**BID FORM**

SW 40<sup>th</sup> Blvd Extension (SW 47<sup>th</sup> Ave – Archer Rd) & SW 47<sup>th</sup> Ave Multiuse Trail (SW 40<sup>th</sup> Blvd – SW 34<sup>th</sup> St)

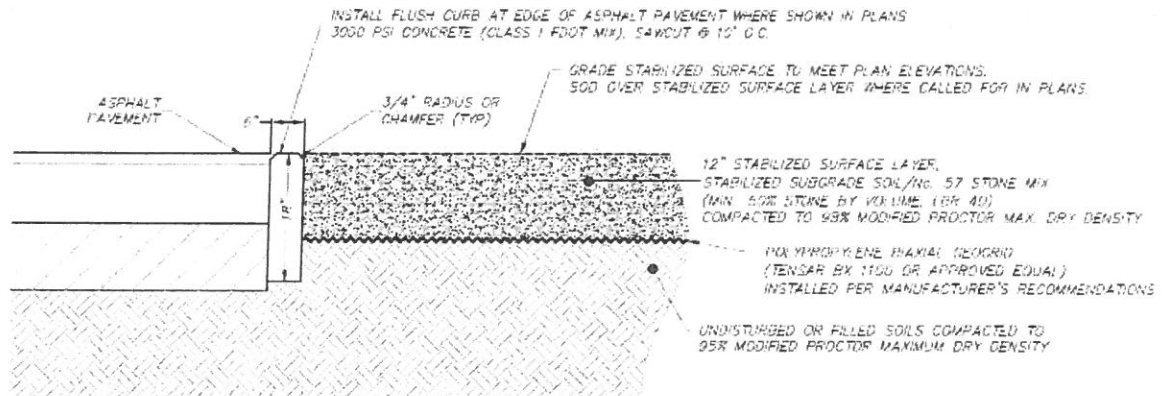
7. Question: What work is covered by the pay item, "Miscellaneous Demolition"? I did not see this covered in the specifications.

Answer: Please refer to FDOT Item # 0110 1 2. This item is described as follows:

*Perform miscellaneous work necessary for the complete preparation of the overall project site as specified in 110-10.*

**INDEX OF ROADWAY PLANS**

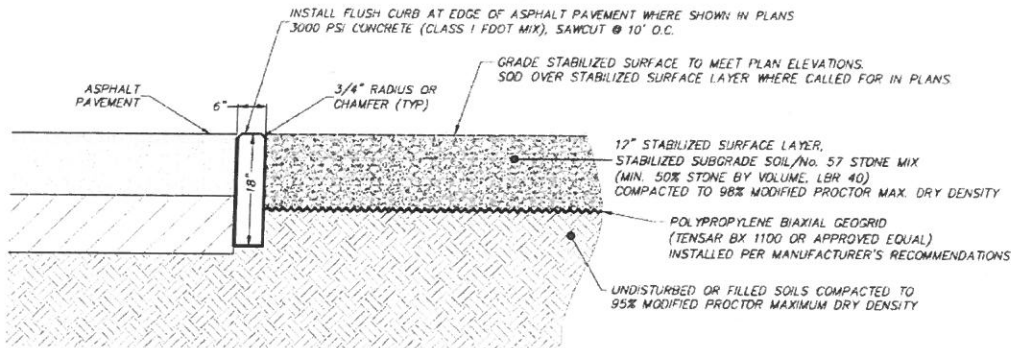
3. Question: Sht.#10 missing from plans

Answer: Correct. Please refer to the cover sheet of the SW 40<sup>th</sup> Boulevard Extension Project. This sheet was not used.

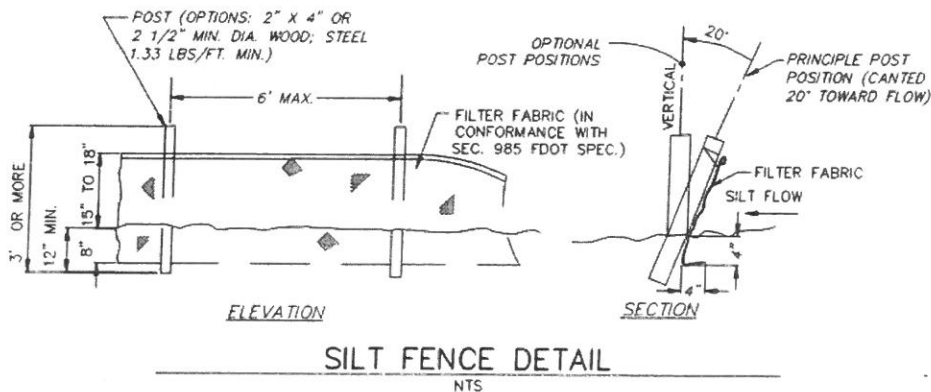
6. Question: Plans indicate Silt Fence, but Pay item is for Staked Turbidity Barrier

Answer: Please use Pay item 0104 10 "Sediment Barrier" instead of Pay item 0104 12. Refer to the silt fence detail on Sheet 11 for typical installation.
